CATALOG PRODUCT NOTIFICATION

Date:	July 24, 2018		
Customer Part Number:	1297-1324-2-ND	Würth Electronics Midcom Part Number:	750316795
Customer Name:	Digikey	Würth Electronics Midcom Inside Sales Rep:	Theresa Tesch
Customer Contact:	Morgan Ness

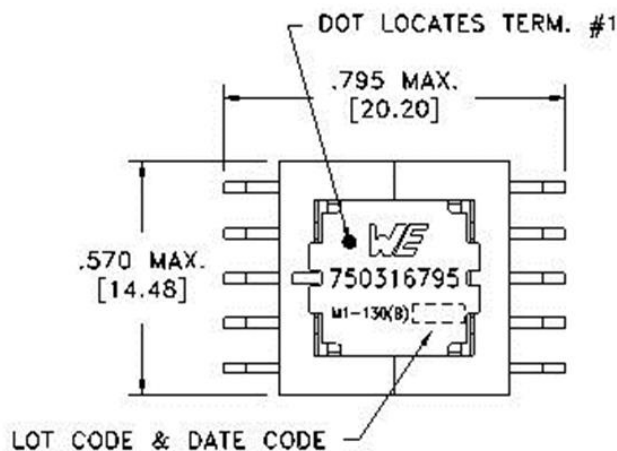
Updating the part to have a Class B Electrical Insulation System on its specification sheet and marked on the part. Also added the clarification that the part is functional insulation only. There was no component changes to the part to meet the insulation system. Please see below what the updated marking on the part will be and the note that will be added to the specification sheet.

UL Recognized Insulation system M1-130(B), E106391. Please note the core is not considered to be dead metal.

Functional insulation only.
